Better Contract Oversight Could Have Prevented  
Deficiencies in the Detention Facility in  
Parwan, Afghanistan

SUBJECT: Better Contract Oversight Could Have Prevented Deficiencies in the Detention Facility in Parwan, Afghanistan (Report No. DODIG-2012-089)

**Figure 1. Examples of Poorly Welded Cell Grates**

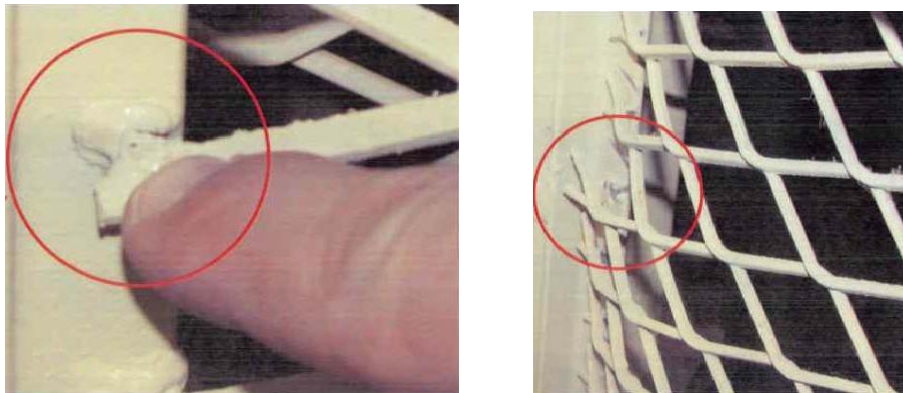
Cell doors were poorly constructed and hung with incorrect hinges, and access doors were missing the magnetic sensors and electronic locks. The contract called for the cell doors to be extra heavy duty, factory fabricated in accordance with American National Standard Institute A250.8 and National Association of Architectural Metal Manufacturers/Hollow Metal Manufacturers Association standards. Based on those standards the cell doors should have had welded frames and full-mortise heavy duty hinges complying with American National Standard Institute/Builders Hardware Manufacturer Association 156.1, spaced appropriately with a minimum of three hinges per door. The cells were to have a wire cage on the front and the doors equipped with all required commercial quality tamper proof hardware complying with applicable portions of American National Standard Institute /Builders Hardware Manufacturer Association standards A156 through A156.24 including closers on personnel doors of Series C02000, Grade 1 adjustable surface mounted type in accordance with American National Standard Institute /Builders Hardware Manufacturer Association Standards A156.4.

In a Construction Quality Presentation in July 2010, Task Force Rocky Mountain officials stated that the construction quality was not up to the standard suitable for a detention facility, and that the quality of construction of greatest interest was the areas where the detainees spent most of their time such as detention cells and the recreation yard. The presentation went on to say that the poorly constructed cell doors allowed detainees to damage the doors easily by repeated kicking. Figure 1 shows examples of the poor welding and Figure 2 shows the damage to the cell doors caused by the detainees because of the poor construction.

*The poorly constructed cell doors allowed detainees to damage the doors easily by repeated kicking.*

Comment: The building was turned over with magnetic sensors and electronic locks in place. The personnel doors were required to be ANSI A250.8 rather than the cell doors as cited above. The personnel doors were installed per the Statement of Work with all hardware being of commercial grade. Detainee or cell doors were fabricated on site.

**Figure 7. The Electrical System Panel (left) and Explanation of the System (right)**

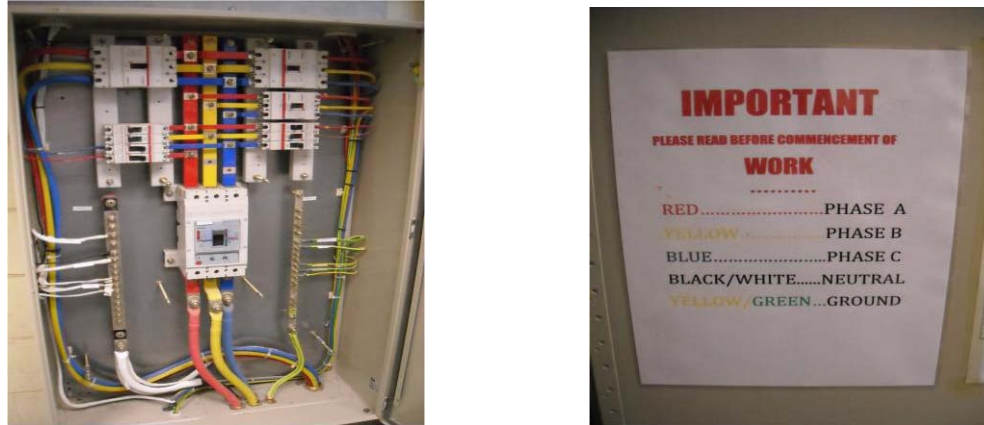
*Distinct differences exist between the U.S. and British standards, especially regarding grounding, bonding, and wiring conventions.*

Personnel who had experience with the British Standard installed the British Standard electrical system during construction, and posted the explanation of the British Standard inside the electrical panels (see figure 7 [right]).

Continued failure to correct the electrical code violations increases the risk of loss of service and the potential of the loss of life for anyone attempting repairs.

Comment: USACE has previously advised that the electrical system was built to US standards with some British equipment. However, the report states that the system is built "primarily to British standards" and that this was done without approval. The voltage system for the DFIP is US (60 Hz) while the color coding in place is British due to the British materials used for this project. It should also be pointed out that even if the system were built to British standards, this would still be in accordance with USFOR-A policy and USACE Transatlantic Division guidance.

Comment: This statement appears to be based on a USACE deficiency report from June 25, 2010, however all grounding and bonding issues were subsequently corrected under warranty.

**Figure 4. Contractor trucks removing sewage from DFIP lift stations.**

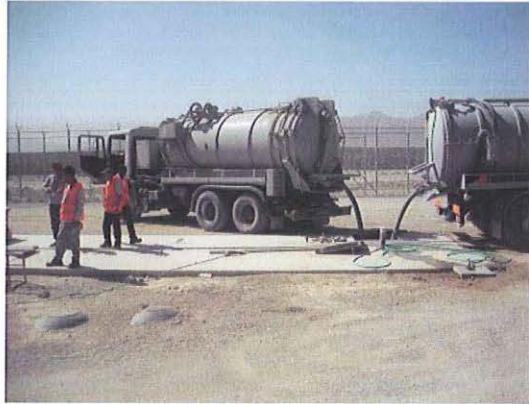
Since the two lift stations are inoperable the sewage began to solidify because the non-waste-related materials flushed down the sewage system are too large and cannot pass through the lift station pumps. With the solid sewage and other items remaining in the two lift stations, the sewage begins to harden. Once the sewage hardens inside the lift station, it causes the waste level to rise above the sewage lines leading from the DFIP buildings as well as the outlet lines that should be used to transfer the sewage to the collection point. On September 3, 2010, Fluor notified TF Peacekeeper that the underground sewage system was rapidly approaching the point to where it will need to be shut down. As of October 25, 2010, lift station number 1 is back online. USACE and PPI are working on a temporary solution for lift station 2. According to USACE personnel the corrections to the two lift stations will help eliminate the need for pump trucks.

To prevent the two sewage lift stations from overflowing, Fluor must bring four sewage removal trucks (see Figure 4) a day into the compound. Because the DFIP is a secure location, every time the trucks have to enter the facility the risk of a security incident increases.

To maintain the health and security of the individuals working and housed at the DFIP, USACE AED-N should require the contractor to immediately repair the lift stations in accordance with the warranty provisions in the contract and ensure the lift stations meet the requirements set forth in the contract.
